FINAL
AS-BUILT BASELINE
MONITORING REPORT (MY0)

MAJOR HILL STREAM AND WETLAND MITIGATION SITE
Alamance County, North Carolina

DMS Project ID No. 100015
Full Delivery Contract No. 7193
USACE Action ID No. SAW-2017-01472
DWR No. 17-0921
RFP No. 16-006990

Subject: Major Hill Stream and Wetland Mitigation Site: As-built Comment Responses
DMS Contract #: 7193; DMS Project ID: 100015; RFP # 16-006990

SHEET NAME	SHEET NUMBER
AS-BUILT STRUCTURES	5
PROJECT NAME: MAJOR HILL STREAM AND WETLAND RESTORATION SITE	
COUNTY: ALAMANCE	DATE: 2018

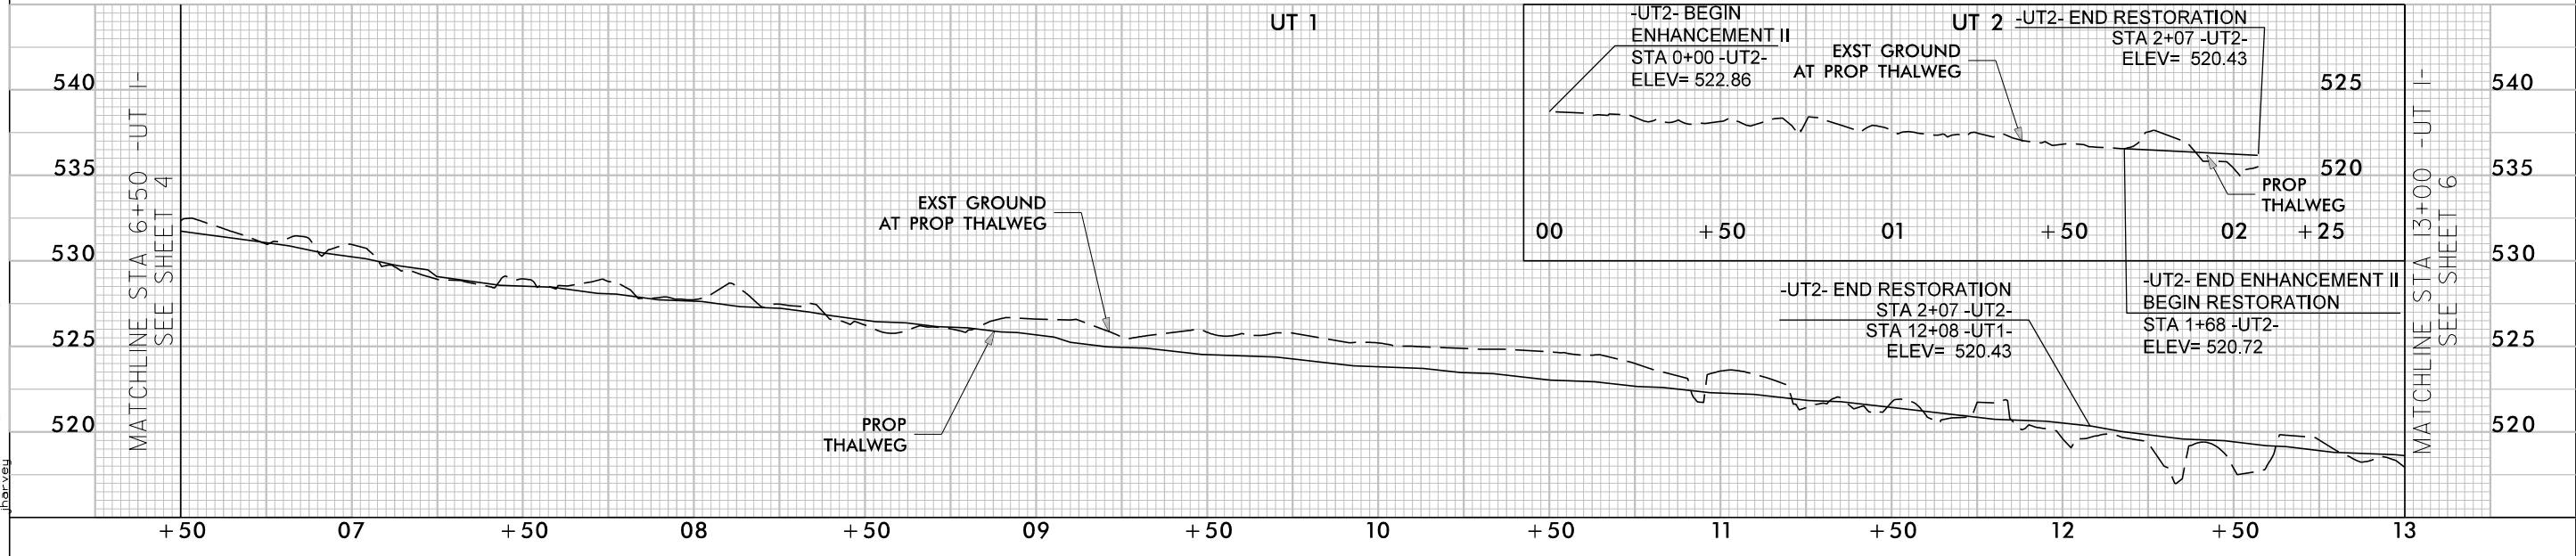
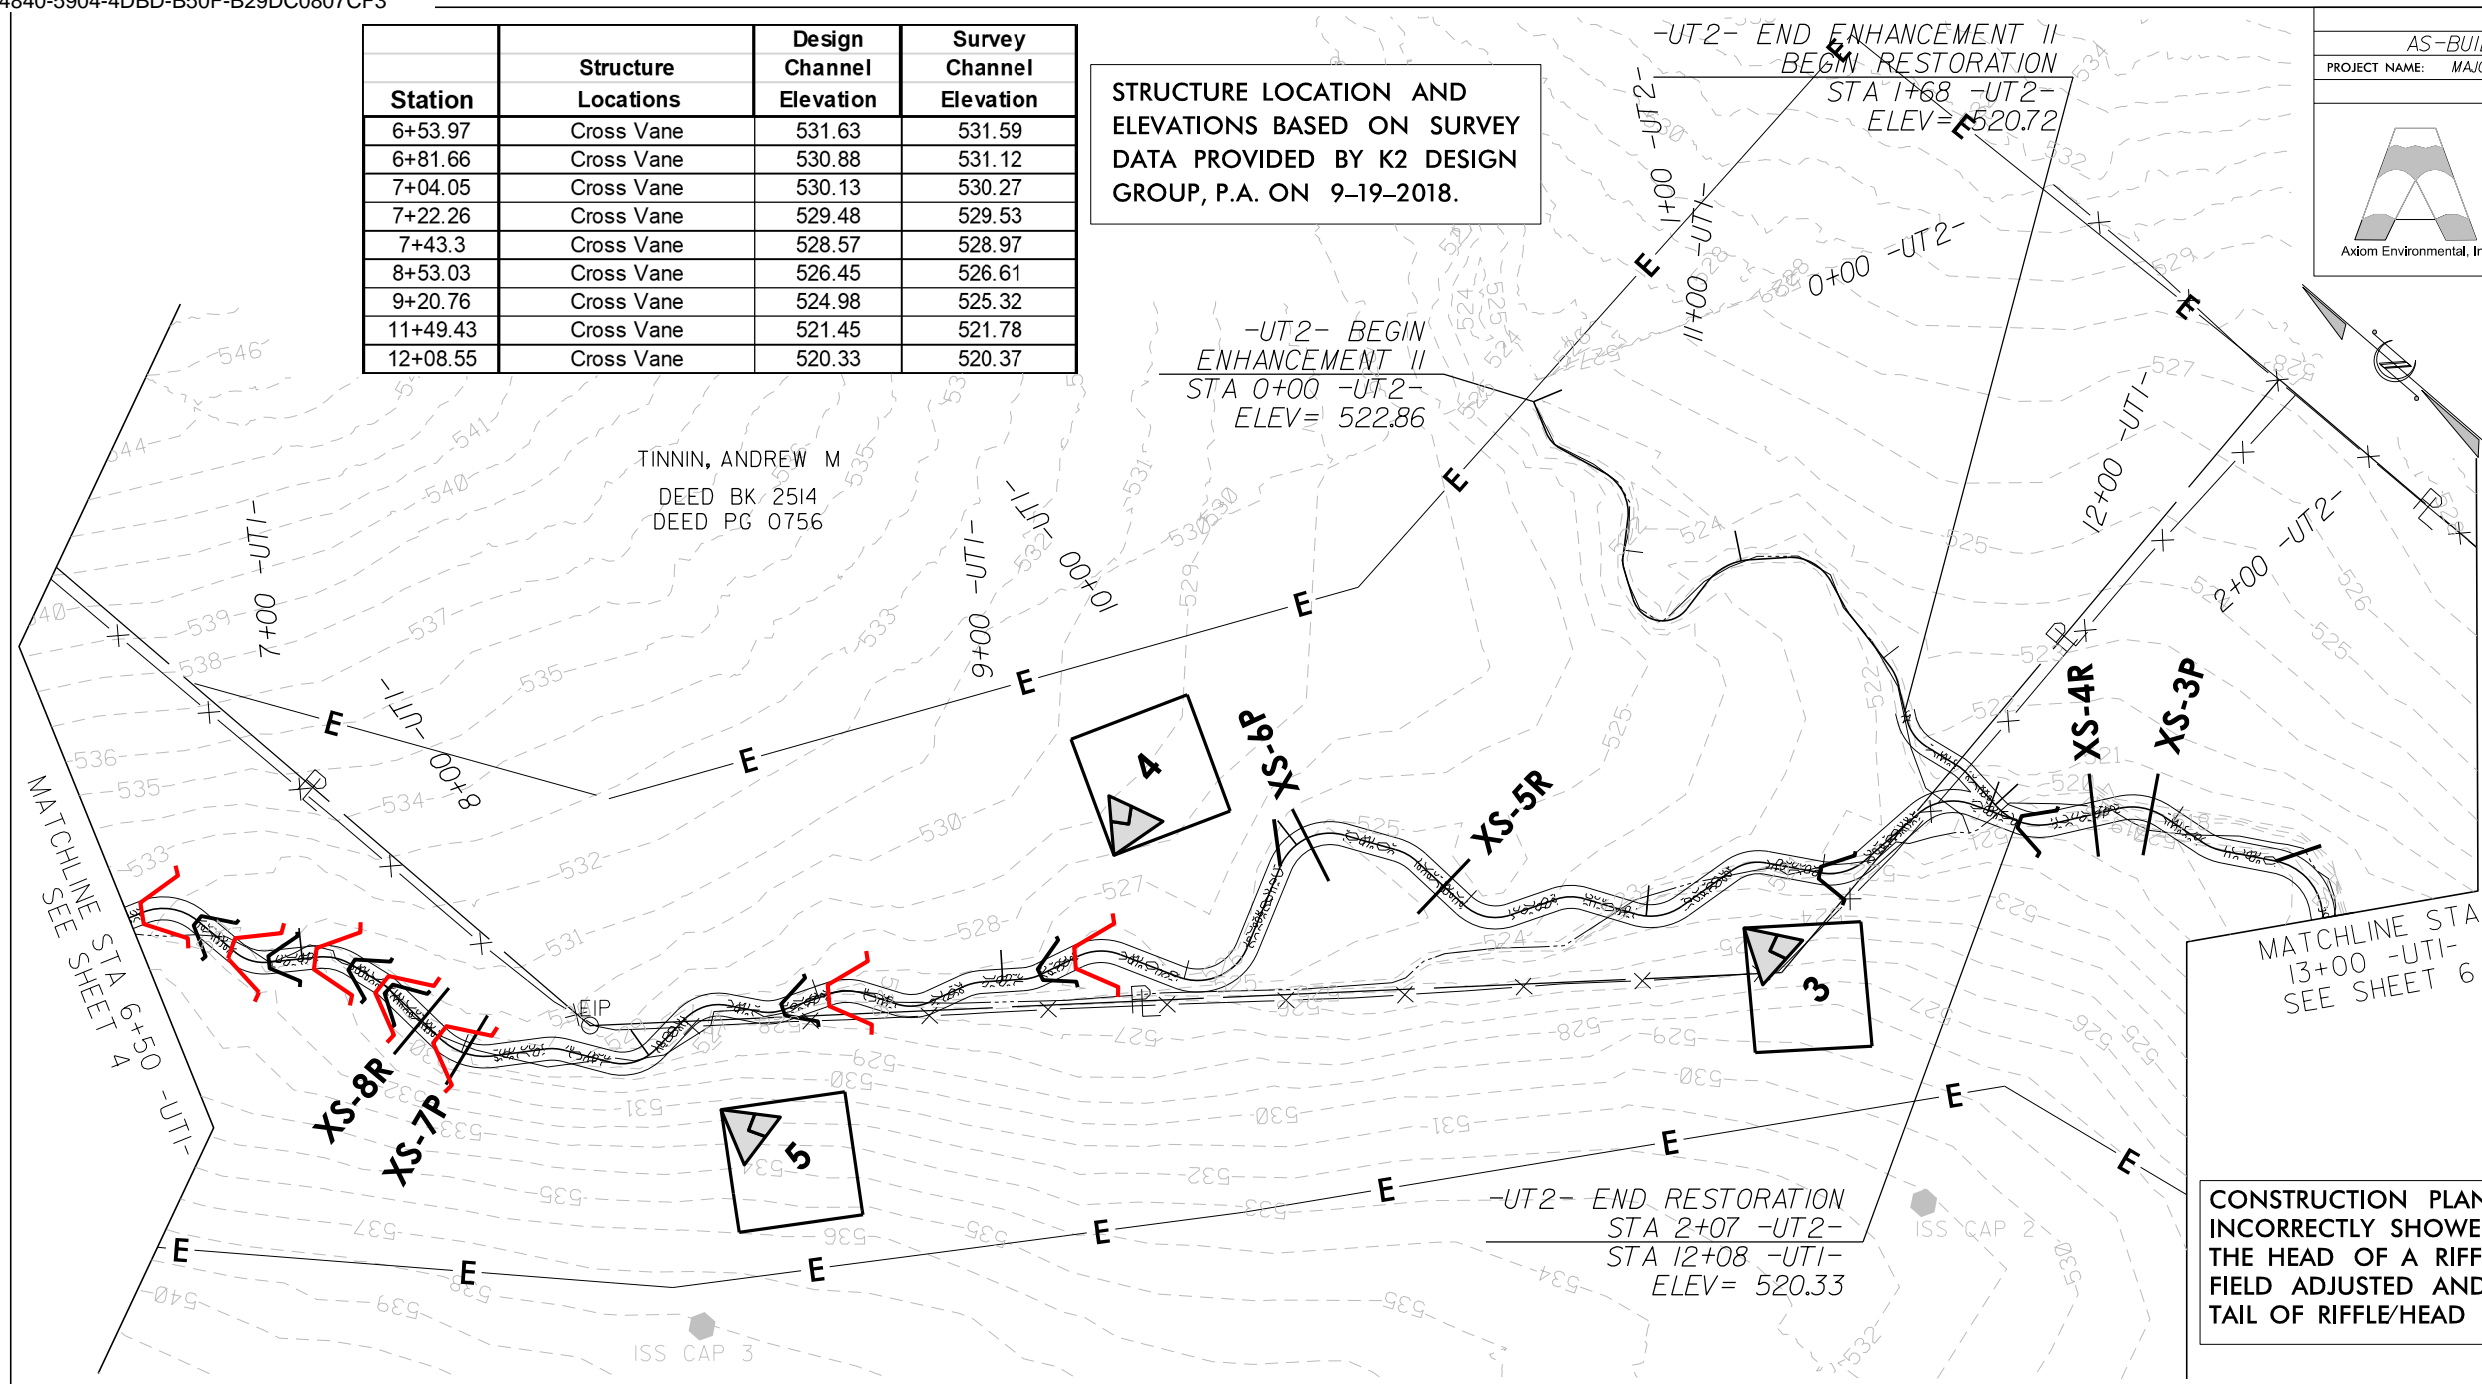
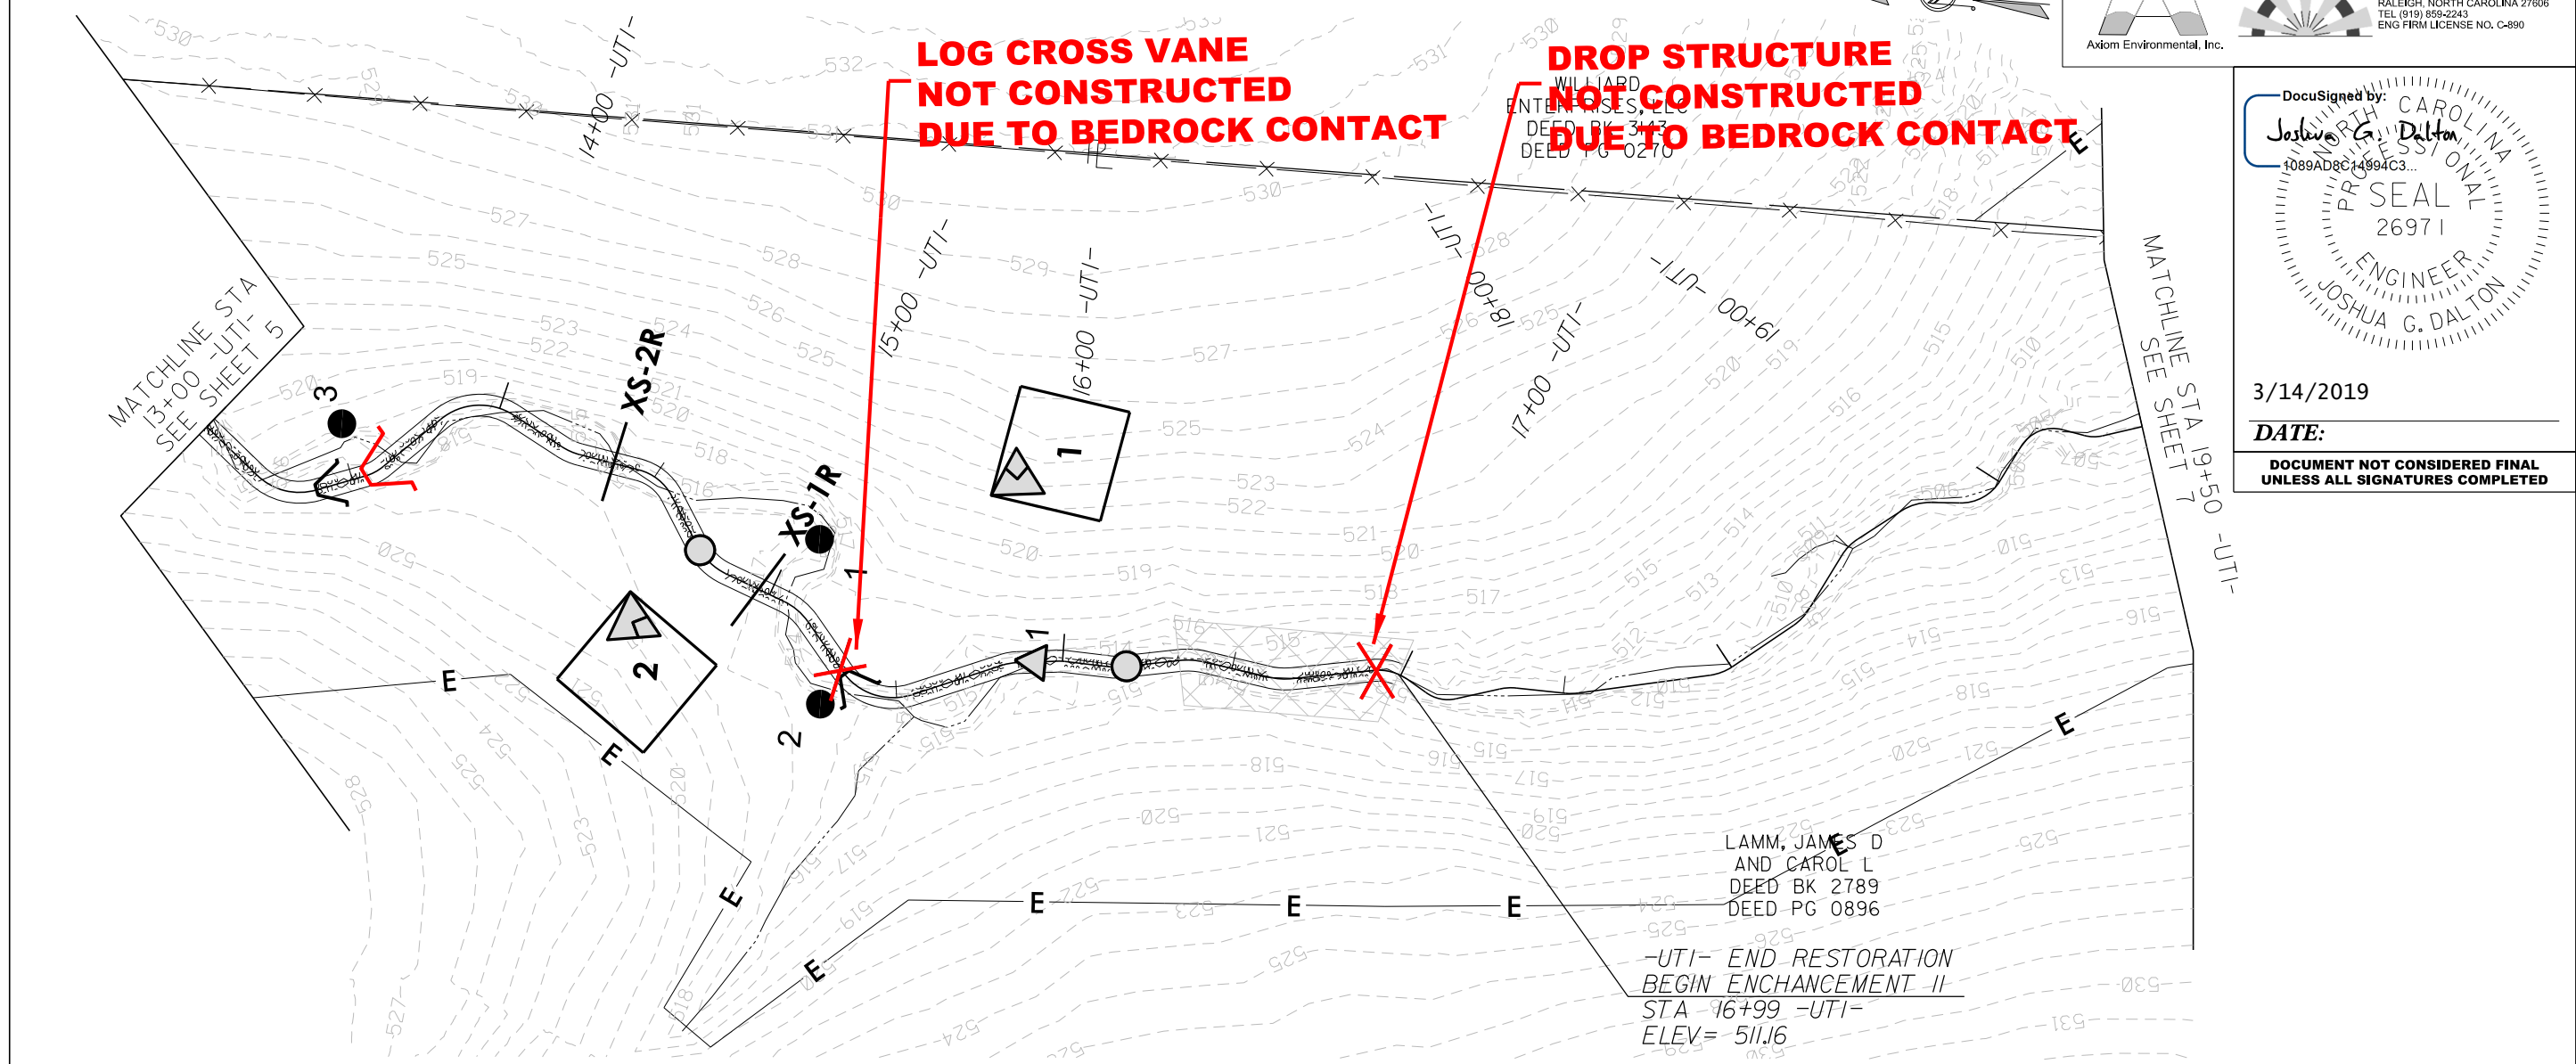
- There were some structures that were not constructed, but there is no explanation as to why or how the grade was maintained. Please provide text explanation. *A note has been added to the construction drawings to indicate that the structures were removed due to contact with bedrock.*

CONSTRUCTION PLANS DATED 07-23-2018 INCORRECTLY SHOWED SEVERAL STRUCTURES AT THE HEAD OF A RIFFLE. THESE STRUCTURES WERE FIELD ADJUSTED AND CONSTRUCTED AT THE TAIL OF RIFFLE/HEAD OF POOL.

PLANTING SCHEDULE

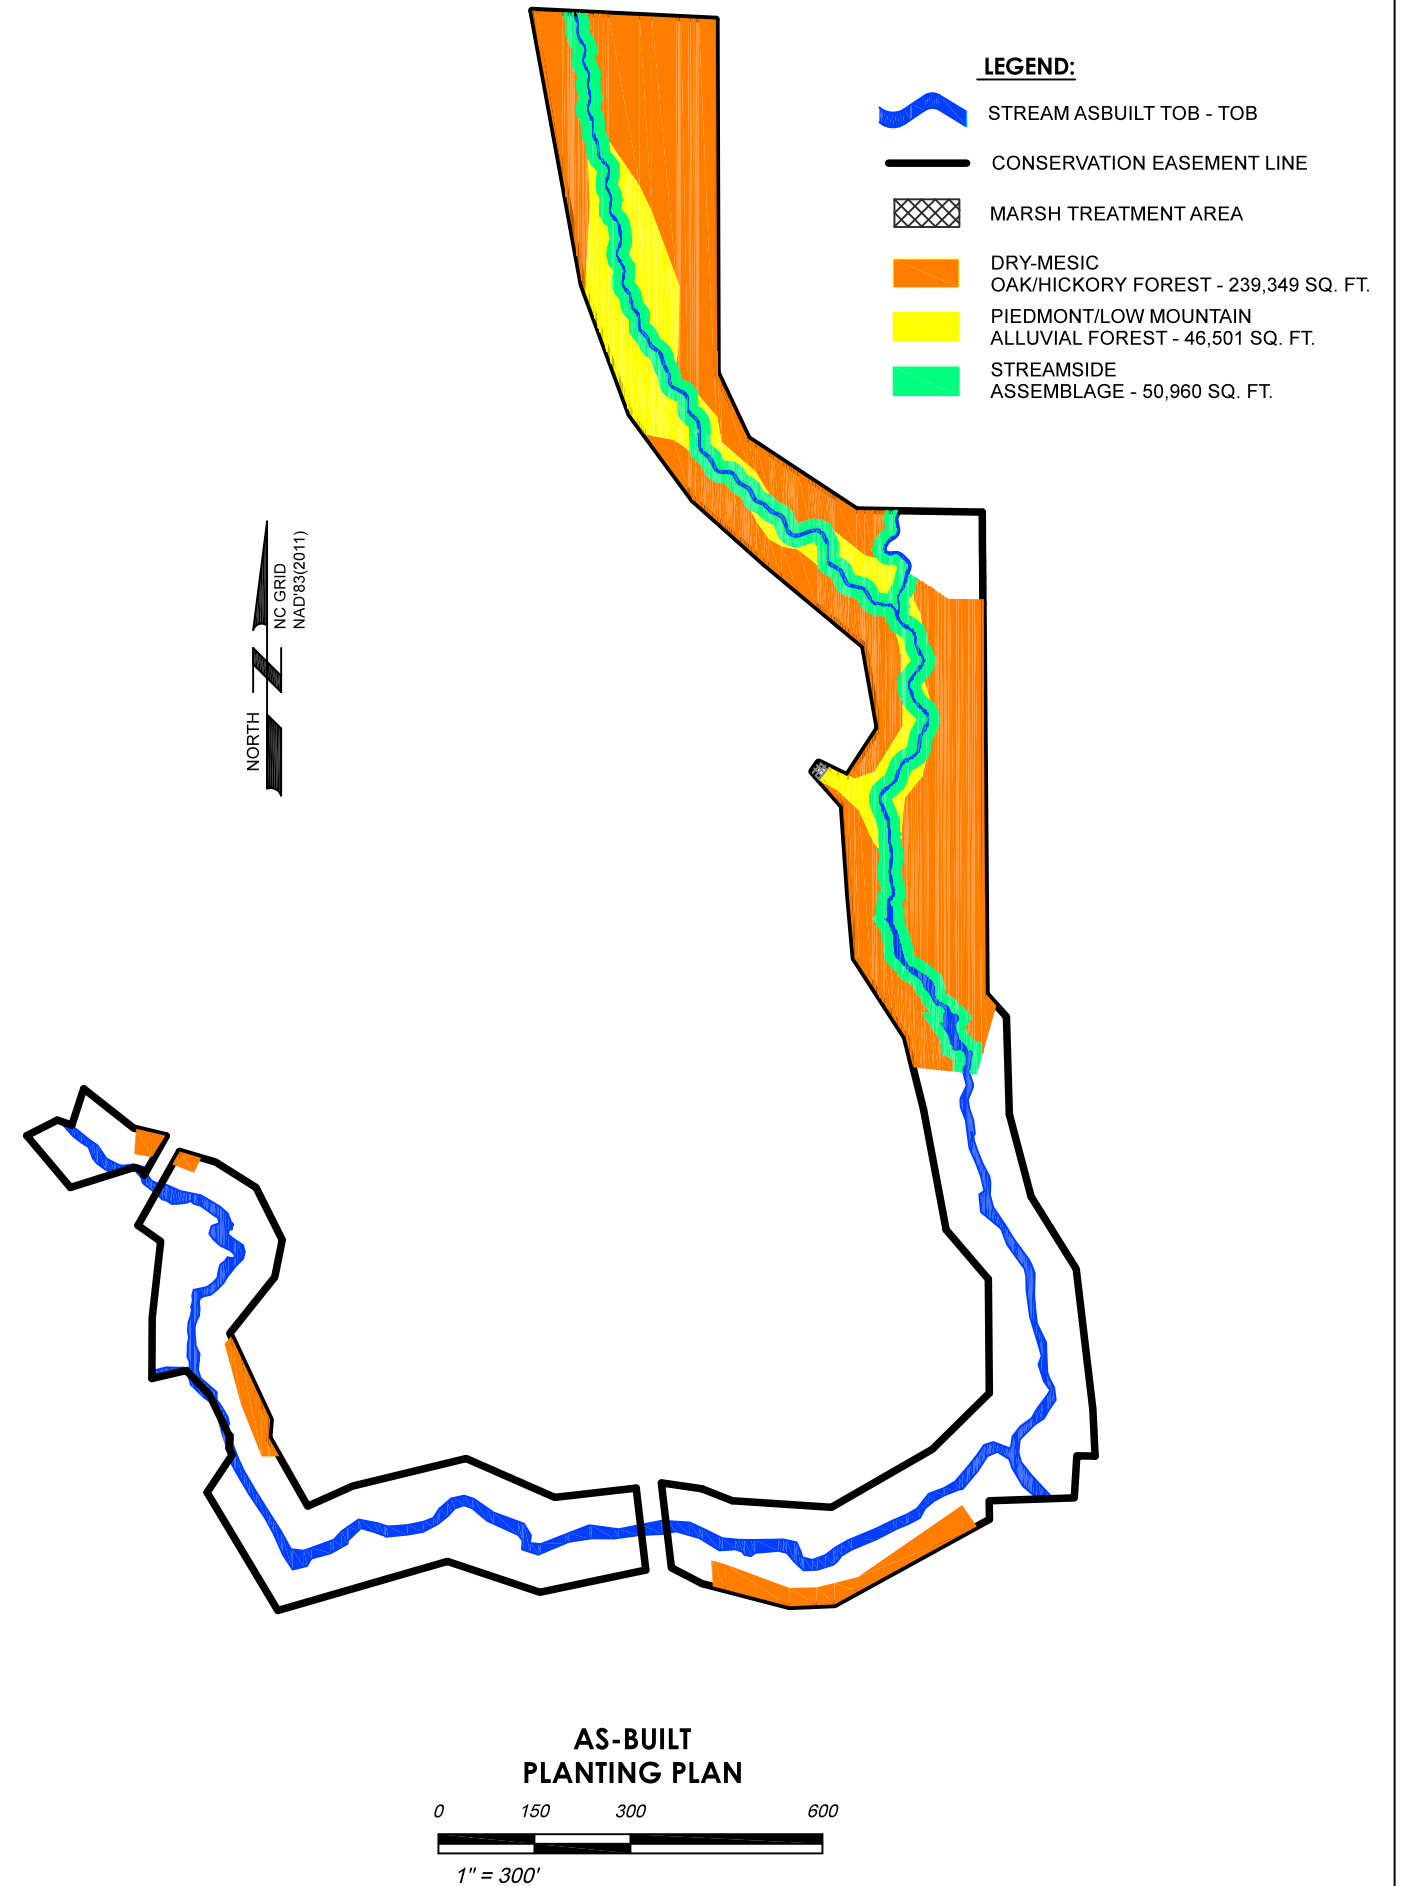
- Sheet 5A (3 of 20), this should show the different planting areas on the map as differentiated in the Mitigation Plan (ex: Pied/Low Mountain Alluvial Forest type should be one area on the map) along with the planting species table. Also, it appears that RS planted the entire easement, but over half of the easement has existing trees. Update with actual ground-truthed planted area, by planting area type. (Something like Table 2 from page 264 of the Mitigation Plan should be included in the As-Built, along with map). *A planting plan, with different planting areas differentiated on the map has been provided.*
